CITY OF ALBUQUERQUE

**Re: Assisted Living Home, 7500 Oakland Ave NE
Grading and Drainage Plan
Engineer's Stamp Date 1-12-15 (C19/D062)**

Based upon the information provided in your submittal received 1-13-15, the above referenced plan cannot be approved for Site Plan for Building Permit action by the DRB until the following comments are addressed:

CITY OF ALBUQUERQUE
 PUBLIC WORKS DEPARTMENT
 ENGINEERING DEVELOPMENT GROUP
ASSISTED LIVING HOME
 LOT 13, BLOCK 3, UNIT 2, TRACT 2, NAA
GRADING & DRAINAGE PLAN

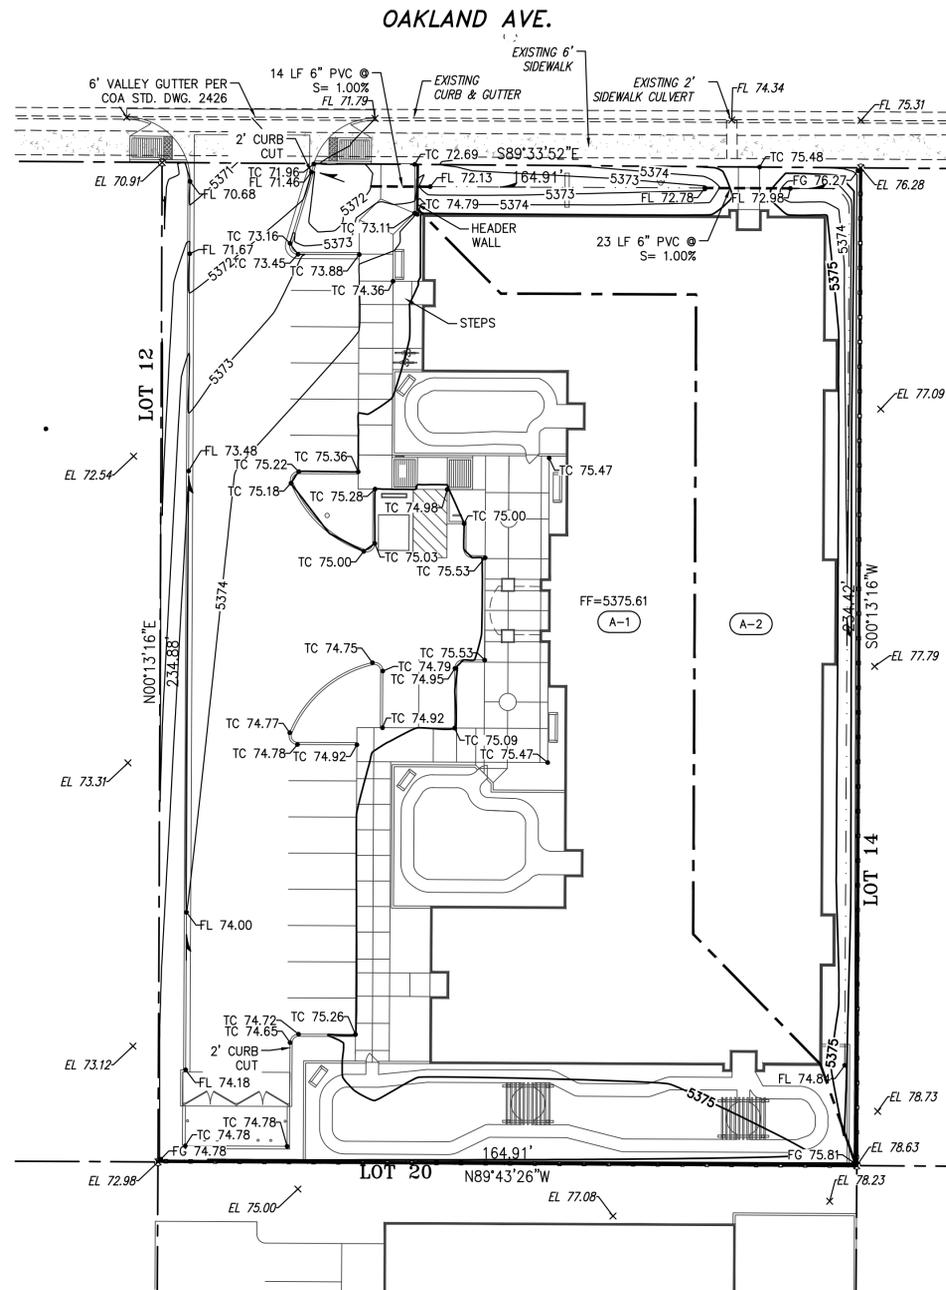
1. The plan is to address and quantify offsite flows. The City recently constructed a sidewalk culvert in Oakland Ave (shown on your plan) to accept flows from the northern basin of the site to the east. These flows are to enter Oakland Ave, without flowing over the sidewalk.

2. There are also offsite flows which appear to enter the southern area of this site which are to be addressed, quantified and accepted.
3. Per the NAADMP this site is allowed 50% impervious area. It proposes more than that. It appears a detention pond will be required. In addition, Quail Springs Estates constructed a 15" storm drain in Oakland Ave. The construction plans show a flow of 12 cfs. The drainage plan is to address how it complies with the NAADMP and the Quail Springs Estates drainage report.

4. Provide existing contours.
5. The plan is to manage the first flush and state how it is doing so. Provide calculations for the first flush volume.
